SB-10058585-9388

Technical Service Bulletin

19 Coolant pipe seepage on turbocharger

19 15 60 2036167/2 June 24, 2015. Supersedes Technical Service Bulletin Group 19 number 14-47 dated January 31, 2014 for reasons listed below.

Figure 1. Black, encrusted coolant residue (outlined area), coolant feed pipe (A), oil feed pipe (B), and coolant return pipe (C).

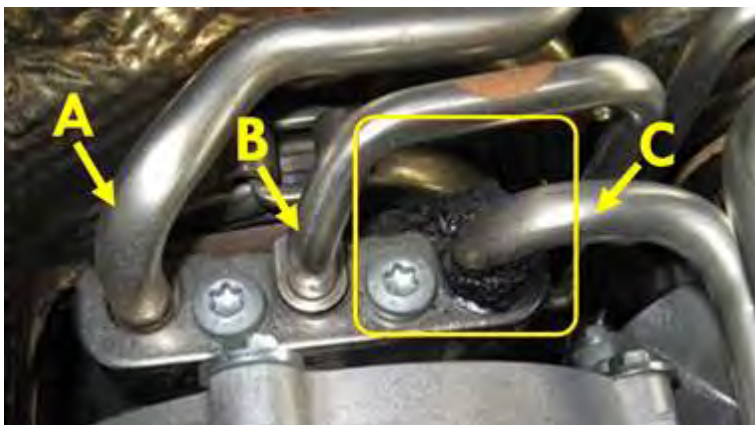
There may be slow coolant loss from the connections of the coolant feed pipe and coolant return pipe. High temperatures cause the coolant to become encrusted on the connection flange of the turbocharger (Figure 1).

Modified coolant feed pipes, coolant return pipes, and o-rings.

1. Drain the cooling system.
2. Replace the coolant feed pipes and coolant return pipes for both cylinder banks.
3. Replace the oil feed pipe o-rings.
4. Tighten the coolant line and oil line hold-down bolts to 9nm.
5. Fill and bleed the cooling system.
